Revised Implementation Plan for Evaluation of Alternative Freshwater Sources in the Topock Remediation Project Area, Pacific Gas and Electric Company, Topock Compressor Station, Needles, California

DOCUMENT ID: PGE20130128A

Comments on Implementation Plan for Evaluation of Alternative Freshwater Sources in the Topock Remediation Project Area, Pacific Gas and Electric Company, Topock Compressor Station, Needles, California (submitted November 20, 2012)

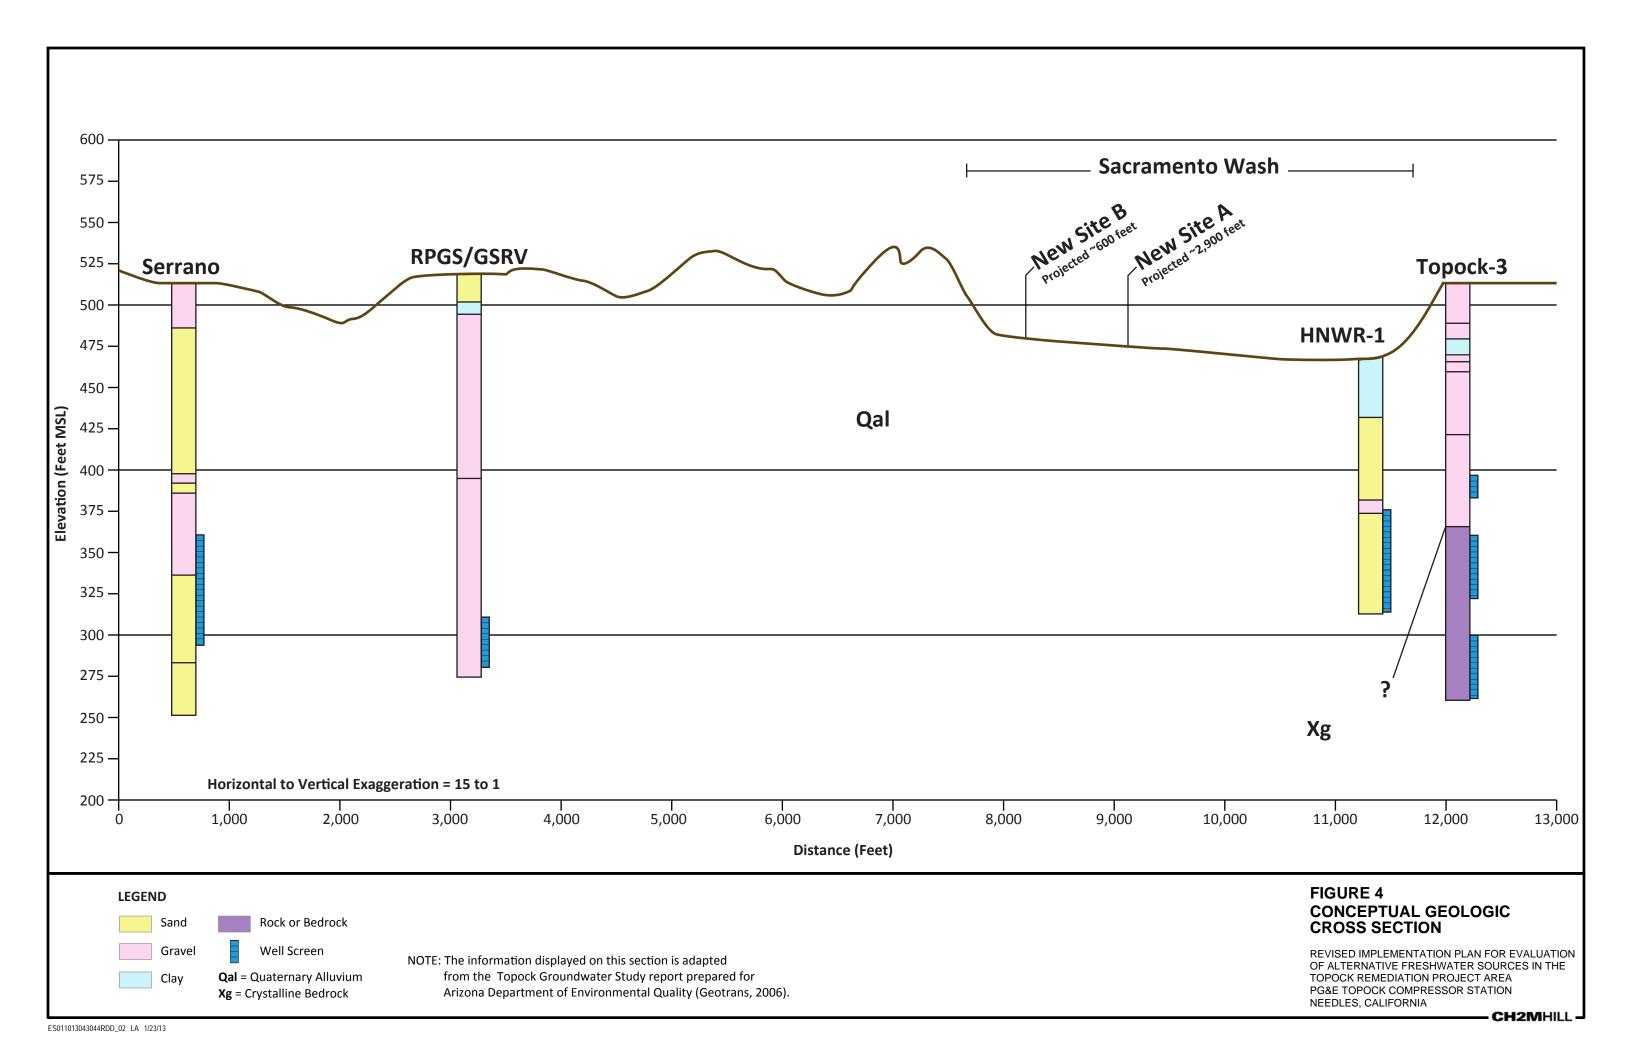
9	DOI	Technical Approach			The maps in the current plan should be revised to include fu well locations and potential discharge areas. Additionally, G		Figures will be updated to indicate approximate well locations, discharge areas, and associated details which have been refined through discussions with the agencies since the initial submittal of the IP. Approximate well location coordinates

Proposed irrigation areas and preliminary equipment layout are indicated on Figures 2 and 3. The Site A and B "sprinkled areas" were selected because they are located in relatively large, flat, previously disturbed areas where discharge activities can be well monitored. In addition, surface topography at Site B is favorable for avoiding runoff during discharge. As planned, irrigation will be conducted using a network of high-volume sprinklers (Nelson® Series 200, or similar) that will be connected by temporary, above grade aluminum irrigation pipes (approximately 4-8 inches in diameter); however, final design and associated details (e.g., pipe diameter, specific sprinkler location and range, etc.) might need to be adjusted based on actual field conditions (e.g., well capacity or location of sensitive biological or cultural resources) at the time of testing. In addition to the discharge area indicated for Site B, if requested by HNWR at the time of work, PG&E will include piping and equipment in the irrigation system such that some discharge water can be delivered to the area of the ongoing Sacramento Wash Revegetation Project. PG&E will continue to coordinate with HNWR to determine the specific area outside of the potential work area that should receive irrigation water (see Figure 3). Personnel will remain on site during the duration of discharge activities to monitor for persistent ponding and runoff. Water will be discharged to these areas in a manner that minimizes ponding and limits the potential for runoff. During discharge, if persistent ponding or runoff towards a jurisdictional channel, the Colorado River, or Arizona County Highway 10 is observed, corrective action (e.g., modification of sprinkler layout, change in discharge rate, or using hand tools to control disperse ponding/control runoff) will be taken. If it is determined that persistent ponding or runoff cannot be easily corrected, then discharge will be discontinued. If rainfall occurs during discharge to the extent that the runoff of discharged water cannot be effectively monitored, then the discharge will be discontinued. It is impossible to predict the infiltration rate of the discharge areas. Therefore, the degree of infiltration and runoff will be closely monitored at all times during discharge. The discharge will be stopped if it is determined that persistent ponding and runoff towards a jurisdictional channel, the Colorado River, or Arizona County Highway 10 cannot be effectively controlled.

FIGURE 5
Summary of Surface Resistivity Data – Sites A and C
Revised Implementation Plan for Evaluation of Alternative
Freshwater Sources in the Topock Remediation Project Area
PG&E Topock Compressor Station, Needles, California

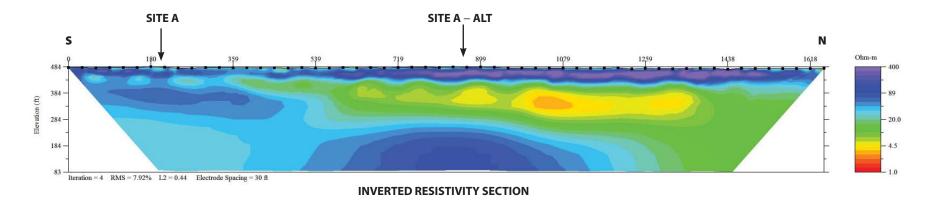
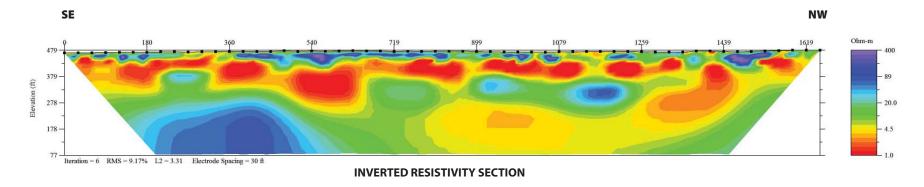
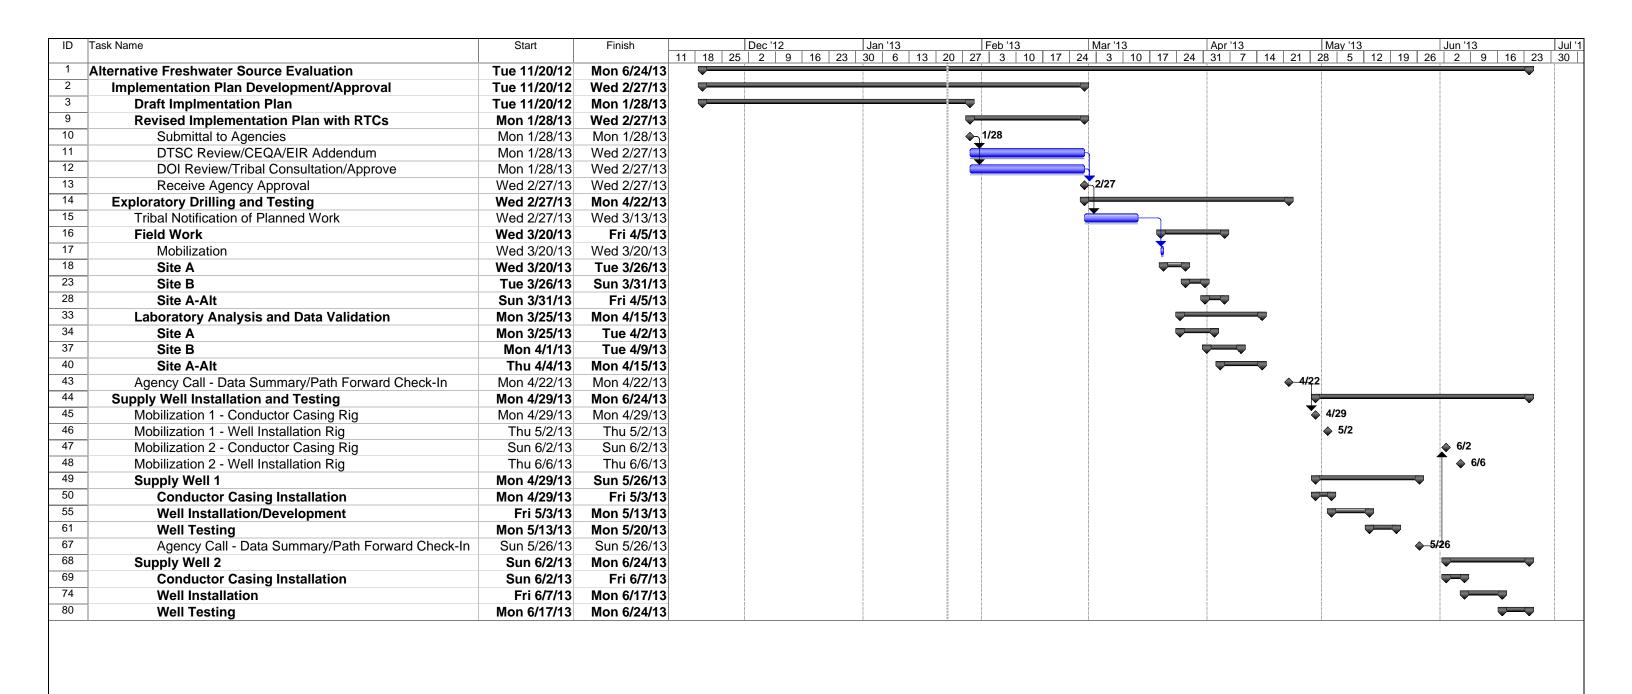
29	DTSC-6	Site C Property lines	Pg 2, 3 rd bullet. Site C	"This site is located in California on either private or Reclamation land"	Please include a figure that shows the land ownership information with boundaries of the parcels. Currently there is no way of understanding what activities are conducted in private land vs. BOR land.	See response to Comment 25.
30	DTSC-7	General Anticipated T- 2/T-3 water quality	Superscrip t 1 for Section 2	"Topock-2 and Topock-3 there are not currently significant differences in the water quality, and there is greater uncertainty about the future water quality as well as the quantity of water available."	DTSC agrees that Topock 2 and 3 do not present any quality difference to HNWR-1. Please explain the basis for stating that there is <i>greater uncertainty</i> of future water quality and quantity.	The casing of Topock-3 is in very poor condition, so the future ability of this well to continue to provide water, especially if the pumping rate were dramatically increased as would be necessary for the remedy, is uncertain. In addition, it is known that poor quality water exists in aquifer below the bottom of Topock 3, so future water quality might decline at increased pumping rates. At HNWR-1, the casing is in good shape so it is not likely to collapse. HNWR-1 is likely in a thicker portion of the aquifer with greater distance to bedrock than Topock 3 and therefore may not be as likely to pull in poor quality water from below.
